Arkansas Nuclear One, Unit 2
Docket No. 50-368
License No. NPF-6

Response to NRC Request for Additional Information on ANO-2 Reactor
Coolant Pump Flywheel Inspection Interval

Response to NRC Request for Additional Information Regarding ANO-2 Flywheel Inspection Extension

FIGURE 1

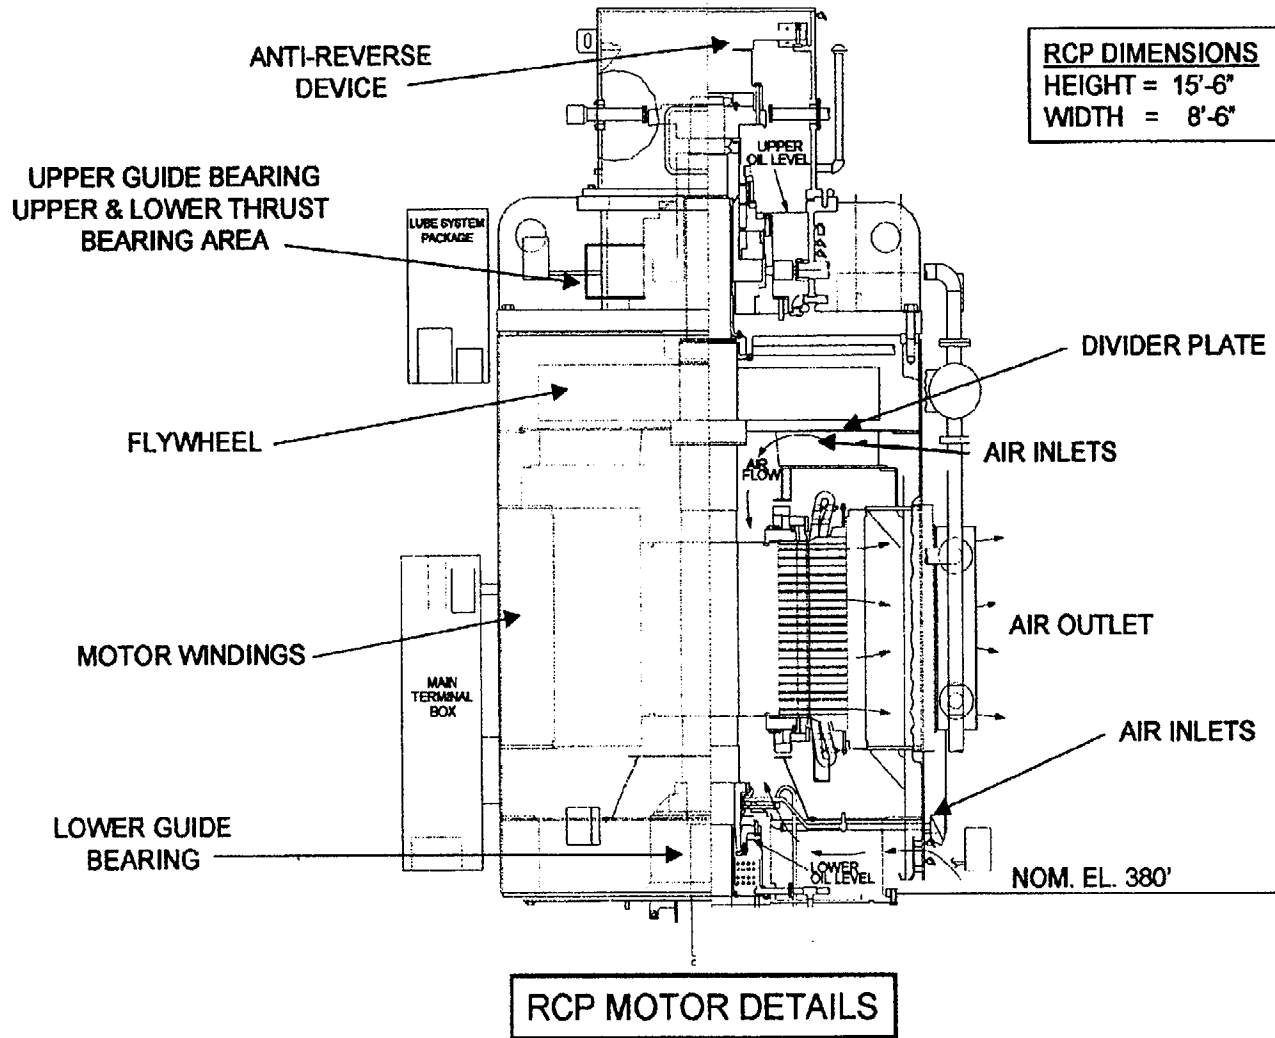
The licensee did not provide any basis for using the nil-ductility transition temperature (NDT) as the reference temperature (RT_{NDT}) for the RCP flywheel material. Based on the two Charpy test data of 63 ft-lbs. and 105 ft-lbs. performed at 150°F, the NRC staff used the American Society of Mechanical Engineers (ASME) Code procedure and determined that the RT_{NDT} value of the RCP flywheel material is 90°F instead of 10°F as stated in the submittal, and the fracture toughness (K_{IC}) is 50 ksi square-root-inch instead of 180 ksi square-root-inch as stated in the submittal. Provide additional information to support your RT_{NDT} value of 10°F. If you plan to propose an alternative methodology in determining the K_{IC} value to replace the use of the K_{IC} versus (T- RT_{NDT}) curve in the ASME Code, you need to submit a relief request.

As noted above, the RCPs run at substantially hotter temperatures than the surrounding air temperatures since they are a source of heat load to the cavity temperatures. As shown on Figure 1, the flywheels are located above the motor windings and below the anti-reverse device and the thrust and upper guide bearings. The RCP stator windings are cooled by drawing air from air inlet locations below the RCP flywheels and then discharging through the stator outlet ports below the RCP flywheels. The flywheel is separated from the stator compartment by a divider plate at the top of the air inlets. The flywheels receive a small amount of cooling air as it is drawn into the motor. The RCPs have installed temperature indicators at various locations throughout the motors. Table 1, with corresponding locations shown on Figure 1; provide a listing of various component temperatures in each of the four RCP motors. This data was collected for the period from January 2001 to January 2002. All components show an average temperature of no less than 122°F. The stator windings provide the greatest heat load from the RCPs, which have average temperatures of greater than 180°F. Even though the flywheel does not have temperature indication, the compartment containing the flywheel is immediately above the compartment containing the motor windings. It is expected that the flywheel compartment will receive significant heat load through conduction and convection from the adjacent compartment with the motor windings. This will provide additional warming of the flywheels.
